**CITY OF MANZANITA**

**PLANNING COMMISSION MEETING**

Re: Design review, Manzanita Deli

**CITY OF MANZANITA PLANNING COMMISSION  
FINDINGS OF FACT AND CONCLUSIONS**

## FLOOR PLANS

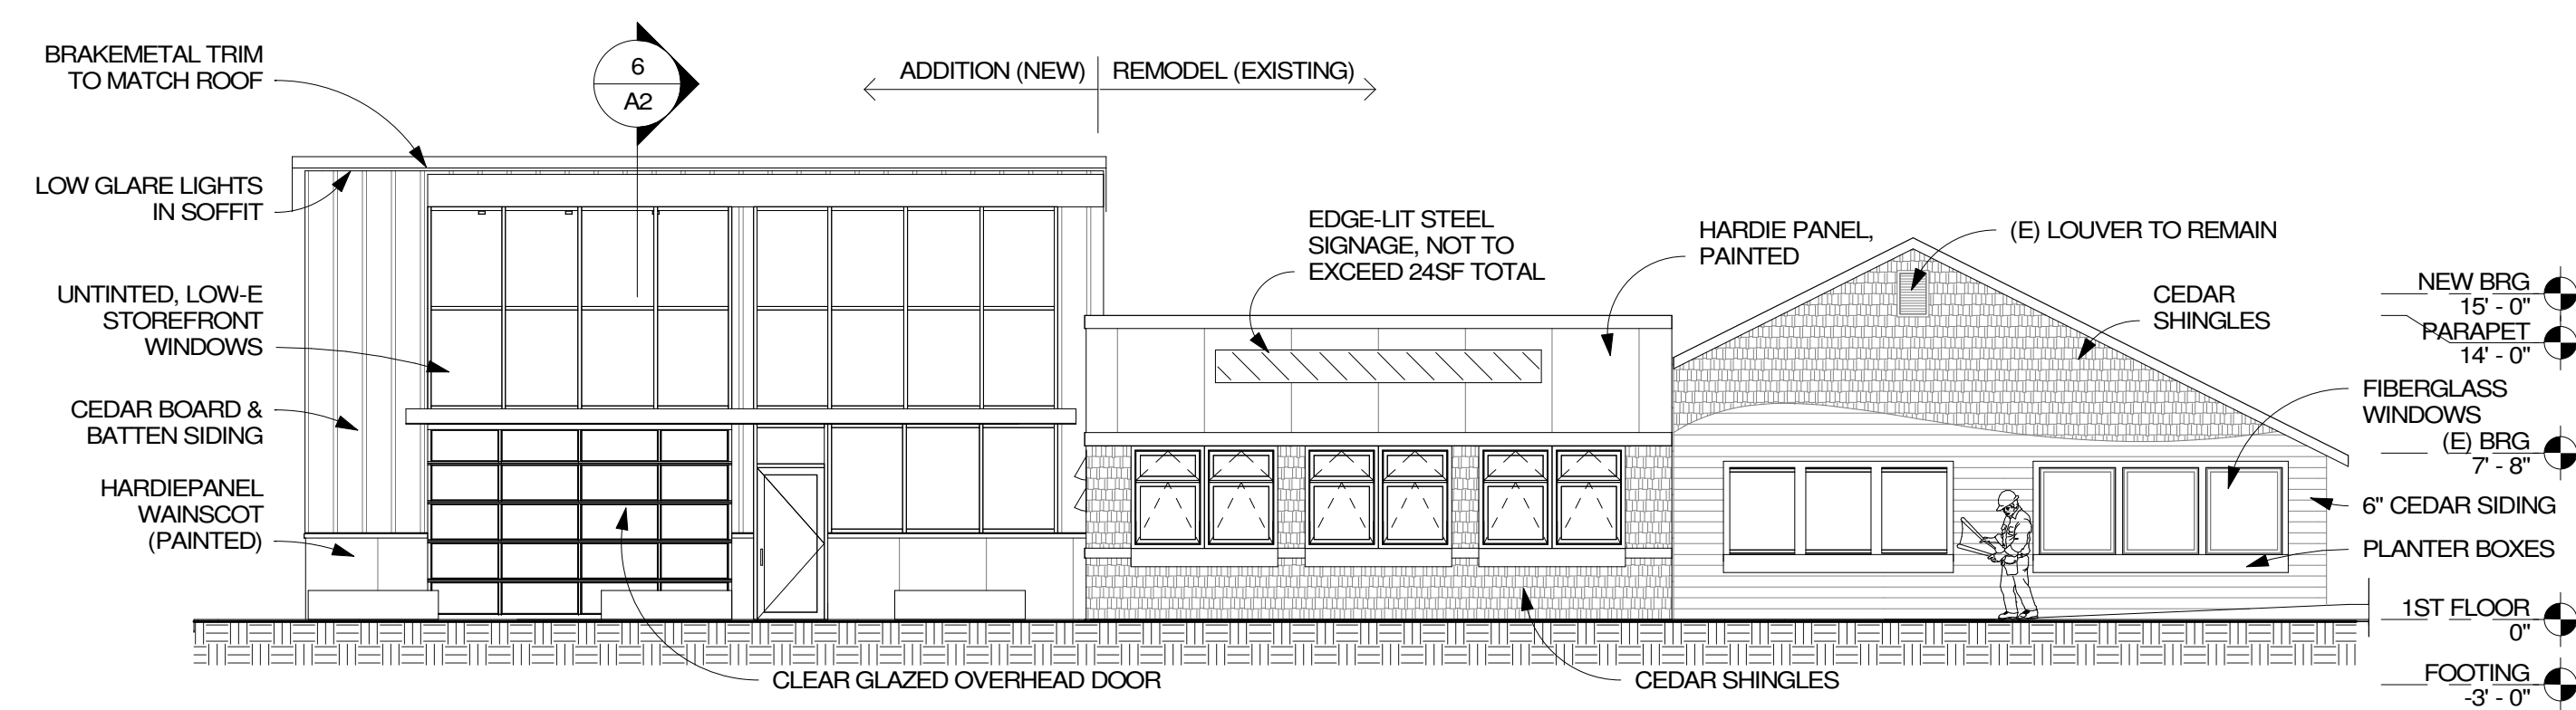
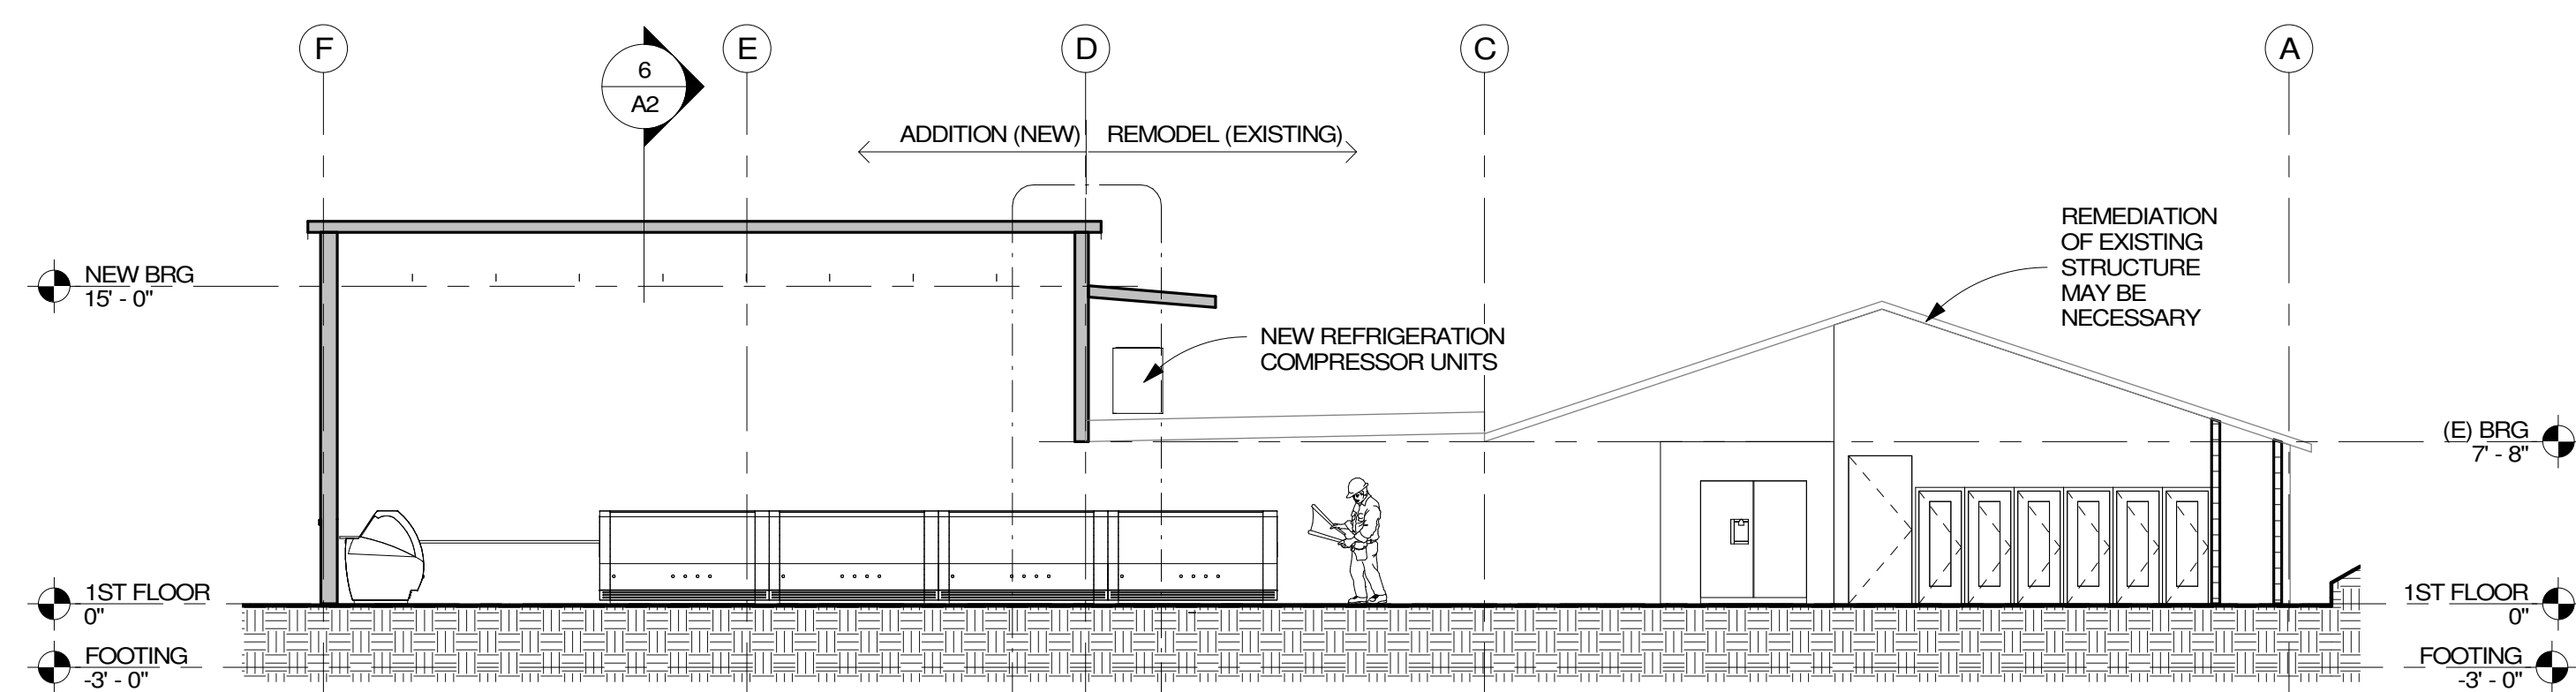
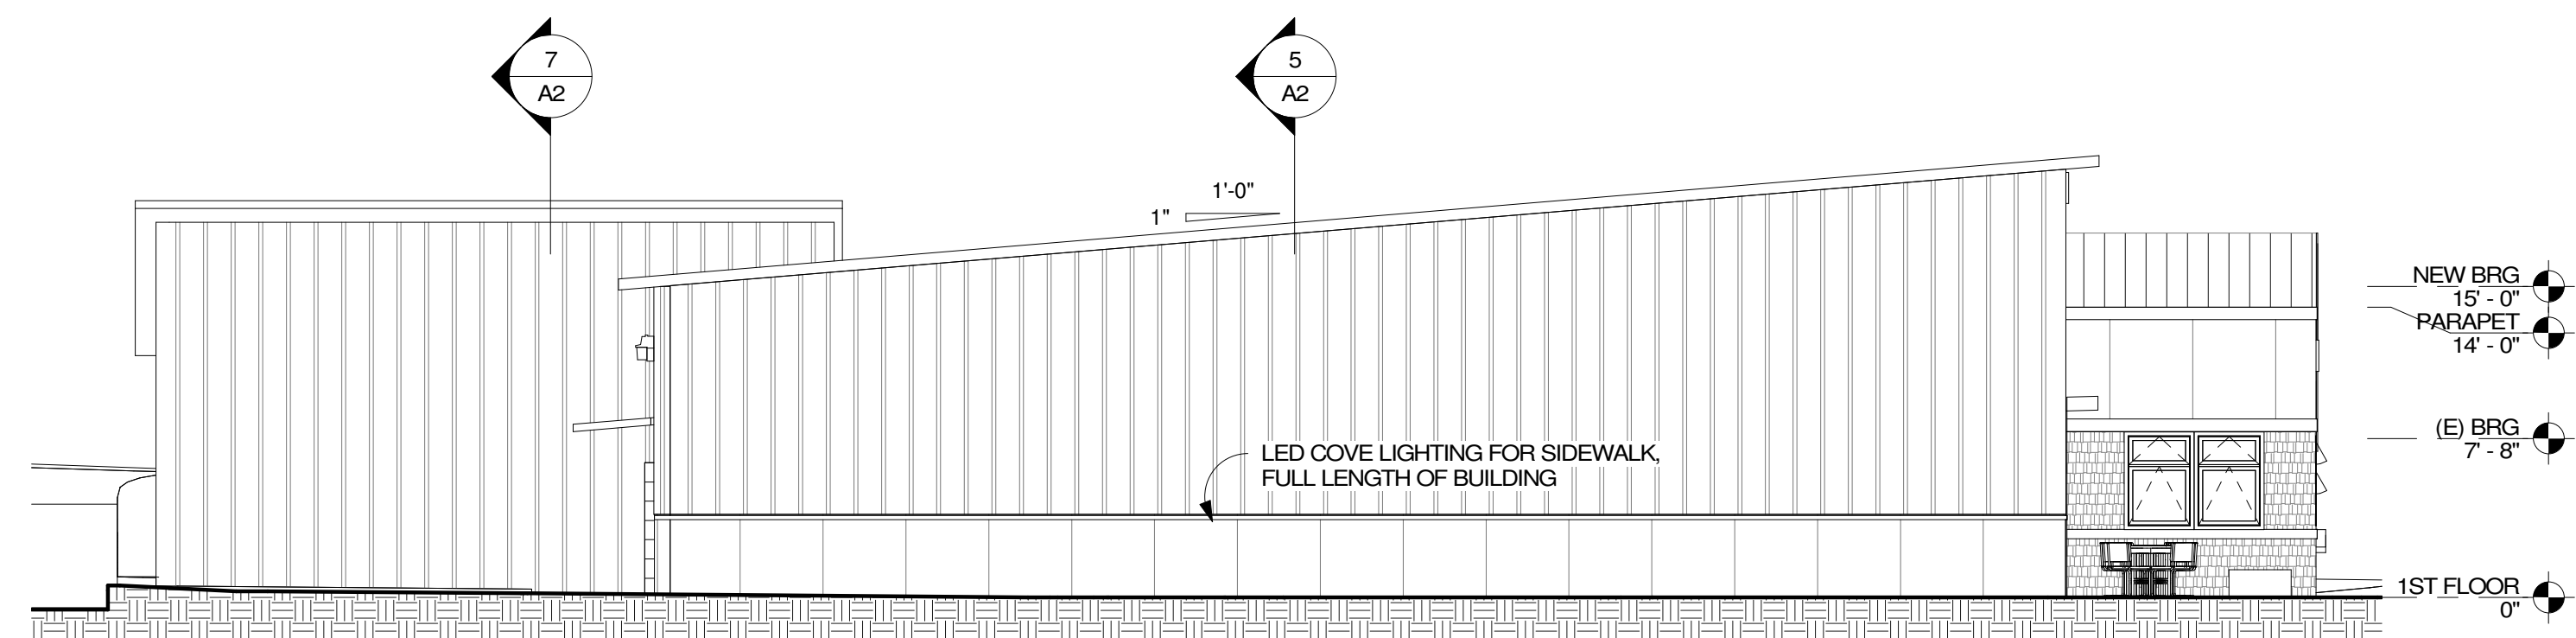
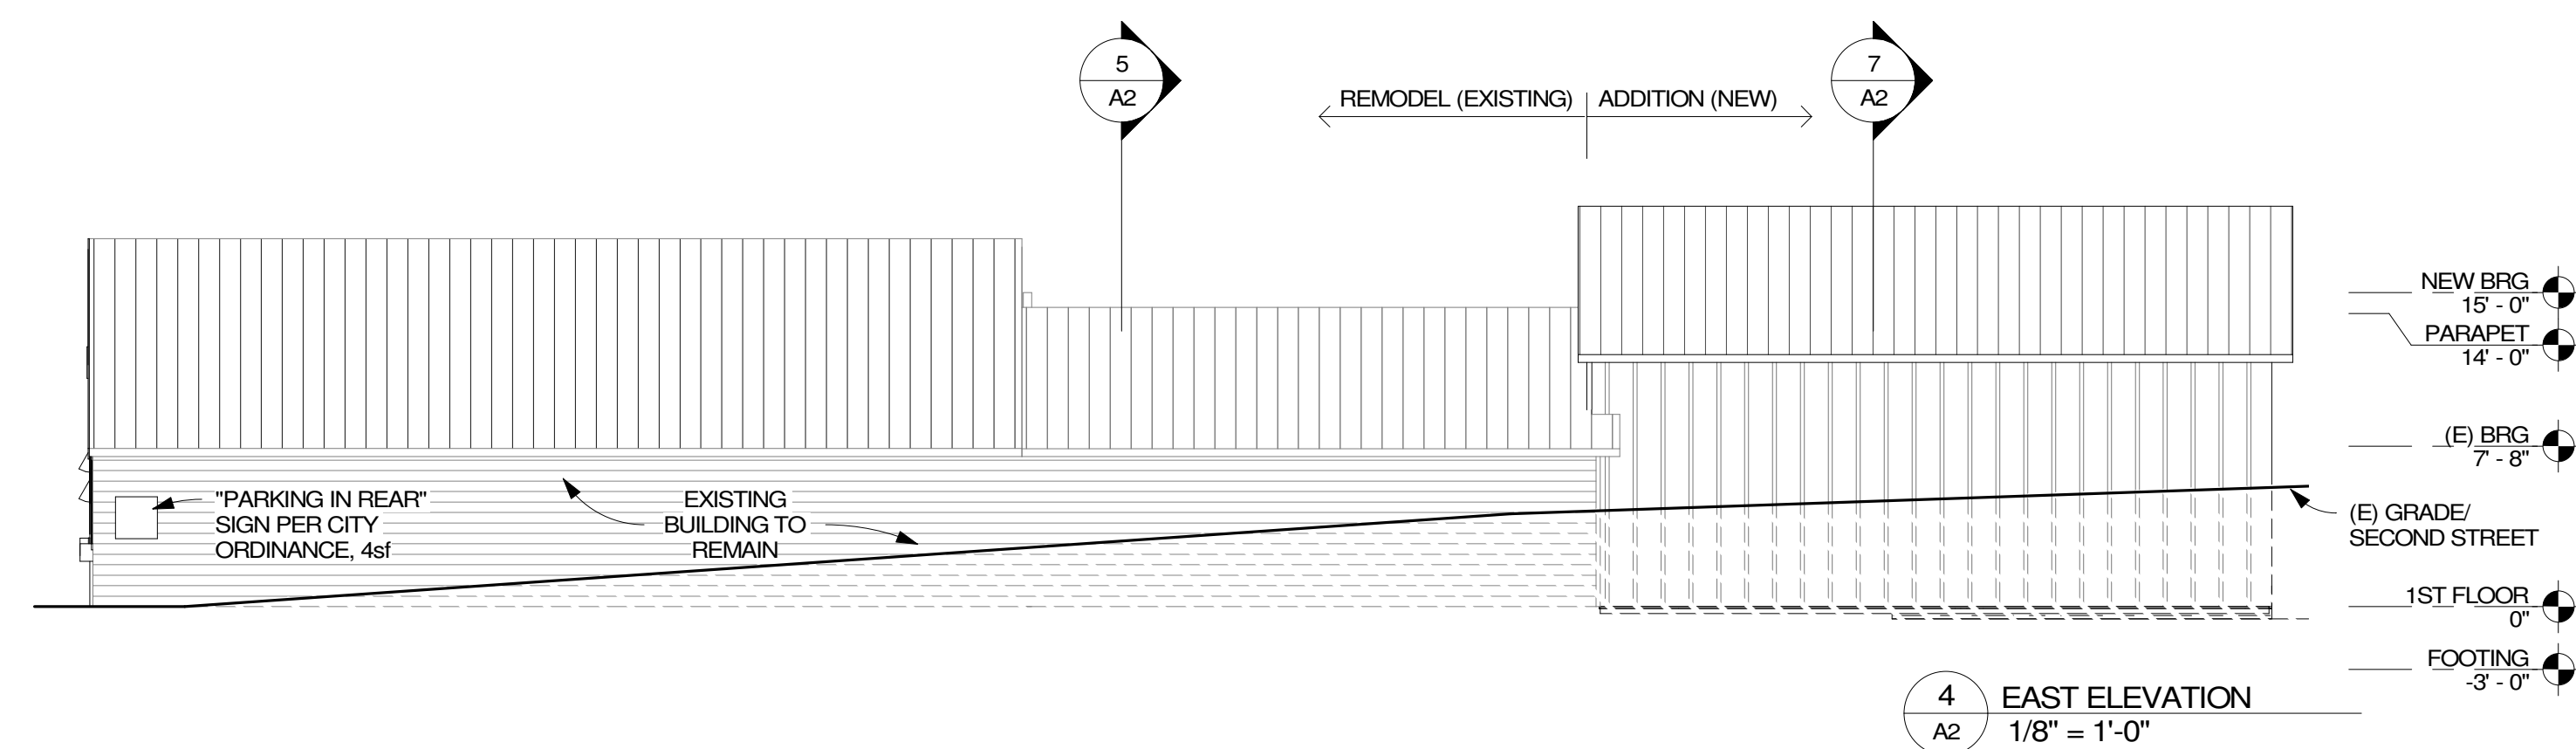
**Findings:** The floor plan shows a gross area of 7,890 square feet. This would require 20 parking spaces ( $7,890/400=19.7$ ).

The proposed site plan shows the required 17 parking spaces.
